A Planning Application by
**CROUDACE HOMES, VORTAL HOMES LIMITED AND
FALCON DEVELOPMENTS (SE) LIMITED**

In respect of
**Land North of School Road, Arborfield Cross,
WOKINGHAM**

Designer's Response

2205-083/DR/02 | April 2025

Location: Proposed priority chicane

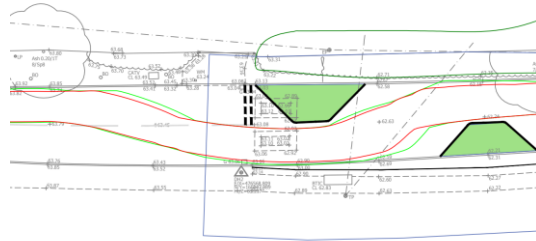
Summary: Potential conflict/kerb strikes if priority chicane arrangement is not sufficiently clear

Although a give way marking has currently been shown on the drawing at the priority chicane, there could be a heightened risk of conflict between opposing vehicles if a motorist fails to observe the marking and give way when required. There could also be a risk of kerb strikes if the physical features are not sufficiently clear to approaching motorists, particularly during the hours of darkness.

It is recommended that signing and other features are included at the detailed design stage as appropriate, to ensure that the priority arrangement and physical features will be sufficiently clear to motorists, including during the hours of darkness.

- 2.3 Agreed – Appropriate signage will be included as part of the detailed design drawings prepared for Technical Approval.

Location: Proposed priority chicane

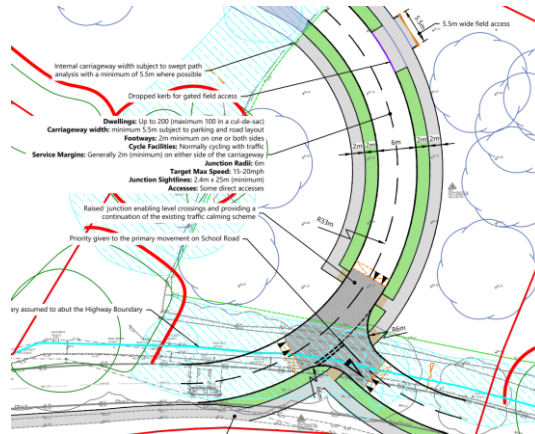
Summary: Position of give way marking and likely path of larger vehicles

The proposed give way marking shown above is very close to the associated chicane/build-out. If a larger vehicle were to stop at the give way line, it may then be necessary for the vehicle to reverse, in order to safely negotiate the chicane arrangement. Any reversing could bring the vehicle into conflict with other road users.

It is recommended that the give way marking is positioned a suitable distance from the build-out, in order that larger vehicles can stop at the give way marking and then safely negotiate the chicane arrangement.

- 2.6 Agreed – If required by the Highway Authority the give-way marking could be set back from the from the chicane build out as part of the detailed design drawings prepared for Technical Approval.

Location: Proposed site access road and priority T-junction

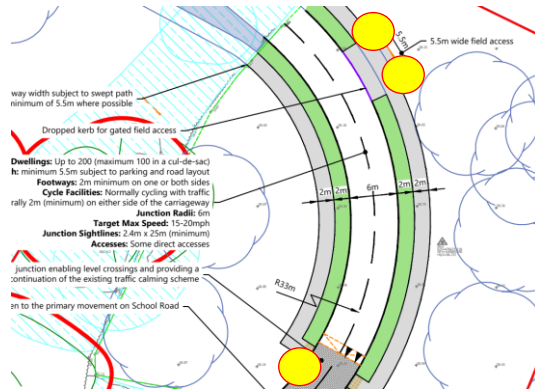
Summary: Provision for larger vehicle swept paths

Although vehicle swept path information has been provided in relation to the proposed chicane arrangement, it will also be important that larger vehicles can safely negotiate the site access road and new T-junction arrangement, without risk of conflict with opposing vehicles or other road users.

It is recommended that further swept path analyses are undertaken in order to ensure that all likely vehicle types and manoeuvres can be safely accommodated within the proposed arrangement illustrated above.

- 2.9 Additional swept path analysis was provided as part of the audit brief demonstrating that agricultural vehicles and a large refuse vehicle can navigate the arrangement. The latter was undertaken for the vehicle requested by the Highway Authority in their consultation response to the previous planning application for the site.
- 2.10 Should additional swept path analysis be required this could be undertaken as part of the detailed design process with minor amendments made as necessary (such as localised widening).
